Access Compliance Report Public Rights-of-Way (Curb Ramps)

Main Street: SIENNA_PKWY Cross Street: MERCANTILE_WAY Location: E

ADA ID: RPRK211022122137 Ramp Type: Type 4 - Parallel Initial Pass/Fail: Pass Overall Compliance: No Severity Score: 26

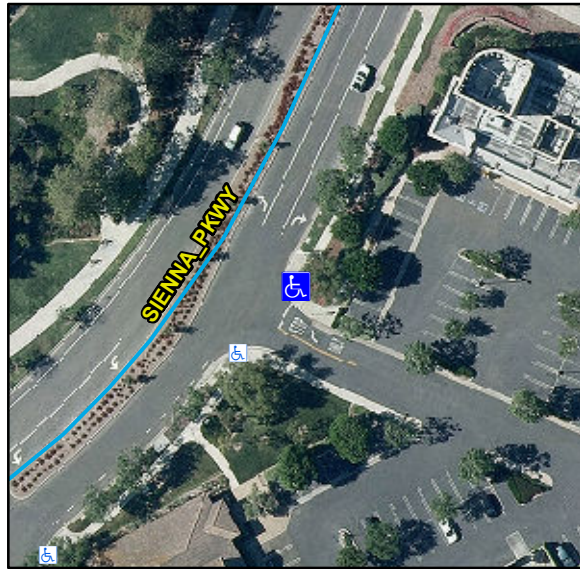
Compliance	Description	Data	Compliance	Description	Data
N/A	Ramp Length LT (in)	90	N/A	Ramp Length RT (in)	90
Yes	Ramp Width LT (in)	48	Yes	Ramp Width RT (in)	48
Yes	Ramp Run Slope LT (%)	5.4	Yes	Ramp Run Slope RT (%)	4.4
Yes	Ramp Cross Slope LT (%)	2	Yes	Ramp Cross Slope RT (%)	1.9
N/A	Landing Present	No	No	DWS Provided	No
N/A	Landing Length (in)	N/A	N/A	DWS Contrast	N/A
No	Landing Width (in)	N/A	N/A	DWS Length (in)	N/A
No	Landing Run Slope (%)	N/A	N/A	DWS Full Width	N/A
No	Landing Cross Slope (%)	N/A		DWS Offset Type	N/A
N/A	Landing Movement Obstructed?	No	N/A	DWS Offset Left (in)	N/A
	Landing Movement Type	Curb	N/A	DWS Offset Right (in)	N/A
N/A	Landing Shared	N/A			
N/A	Clear Space	Yes			
N/A	Clear Space To Crosswalk (in)	48			
N/A	Marked Crosswalk 1	No	N/A	Marked Crosswalk 2	No
	Crossing 1 Direction	NW		Crossing 2 Direction	SW
N/A	Marked Crosswalk 1 Width (in)	N/A		Marked Crosswalk 2 Width (in)	N/A
N/A	Ramp Inside Crosswalk 1	N/A	N/A	Ramp Inside Crosswalk 2	N/A

Crossing 1 Slope (%)	1.4		Crossing 2 Slope (%)	0.1
	Crossing 1 Cross Slope (%)	2.7		Crossing 2 Cross Slope (%)	0
Yes	Gutter Ponding	No	No	Curb Slope	8.5
Yes	Gutter Lip Height (in)	0		Road Run Slope (%)	2.1
No	Gutter Run Slope (%)	6.1		Road Cross Slope (%)	0.2
Yes	Gutter Cross Slope (%)	1.9	No	Perpendicular Joint Present	No
Yes	Overall Surface Condition	Acceptable			
	Cross Gutter Present?	No		Spandrel Present?	No
	Replace Cross Gutter?	N/A		Replace Spandrel?	N/A

Remove & Replace Curb Ramp With Two New Directional Ramps or Equivalent. Remove & Replace Gutter.
